**ABBATTITORI/CONGELATORI
BLAST CHILLERS AND FREEZERS**

BLAST CHILLERS/FREEZERS 28kg GN 1/1 CROSSWISE

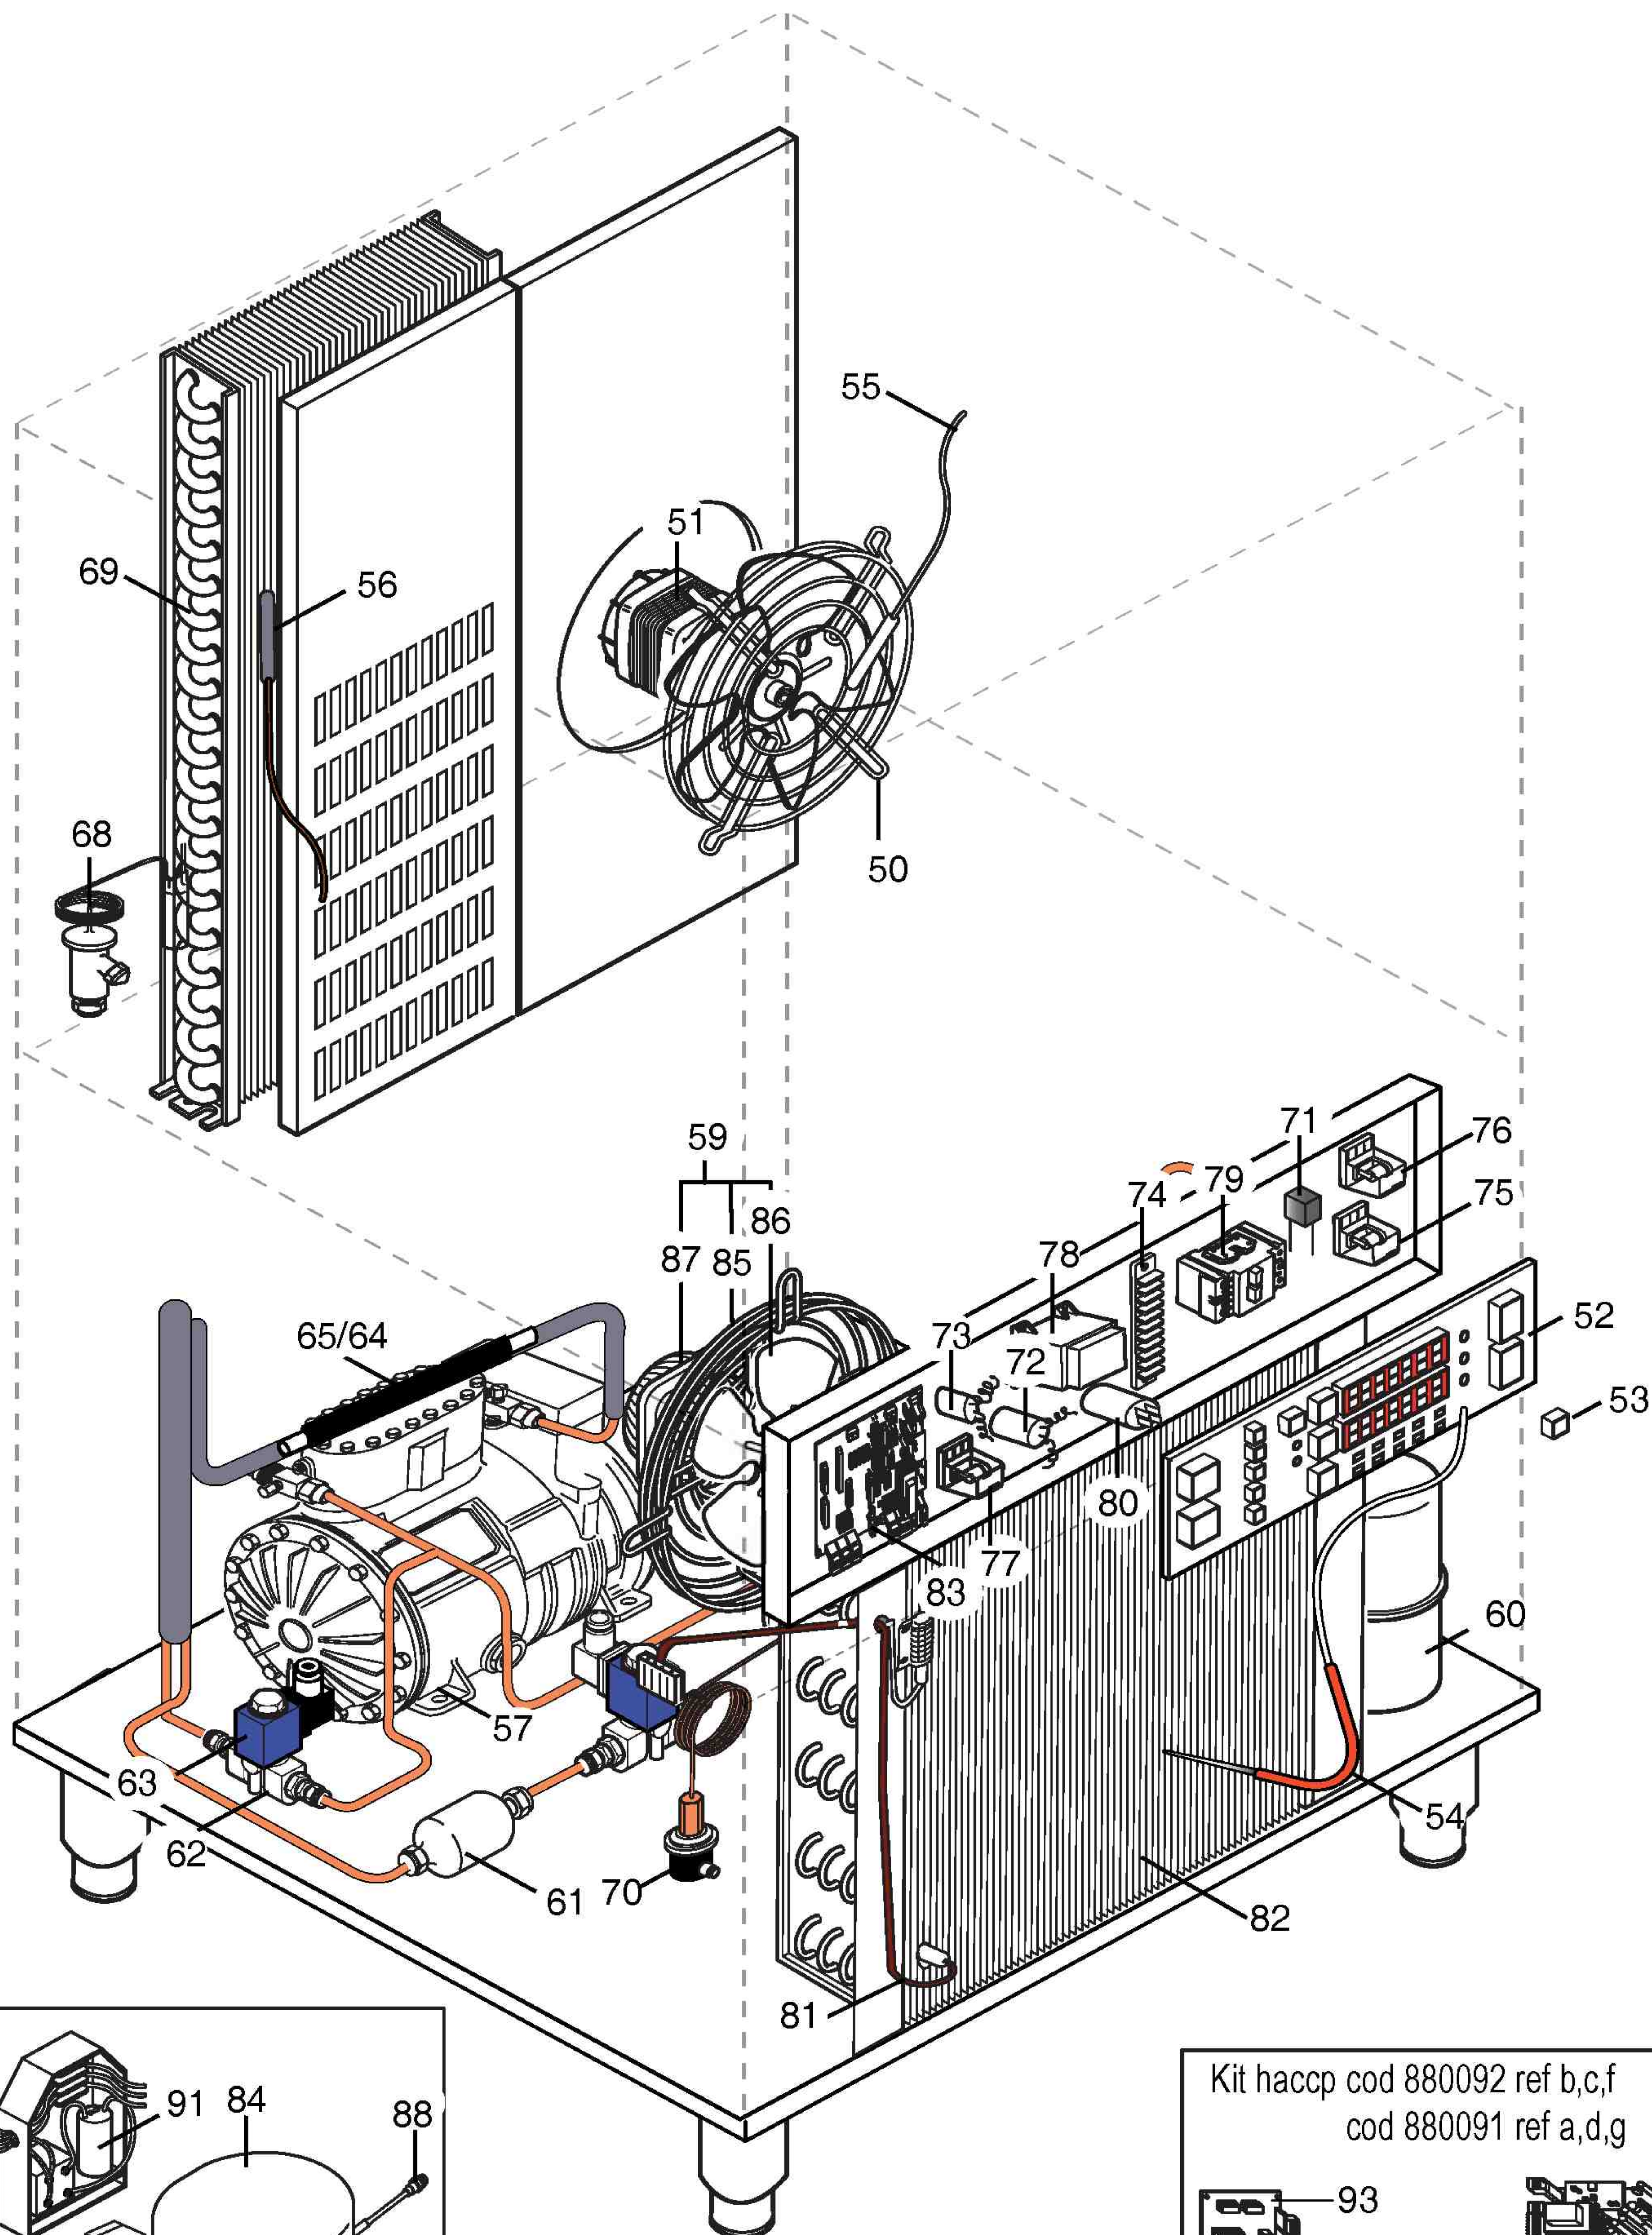
Has been change the user board and food probes from ser.N°01700001 due to a new connectors. Please for other information look the tec.doc n°VTX.2010-03

update from serial number ~ 83000001 change thermostatic valve on codes 728450-110722-728215-727132-726629

update from serial number ~ 70500001 change estetic in codes 728211-728215-728308-728450

update from serial number ~ 5200001 change estetic in codes 726629-726622-726623

new evaporator probe from ser.numb.~ 51100001

from serial number ~ 51800001 as been remove vibration damping

From ser. N° ~ 71600001 are changed the board main and user and sticker control
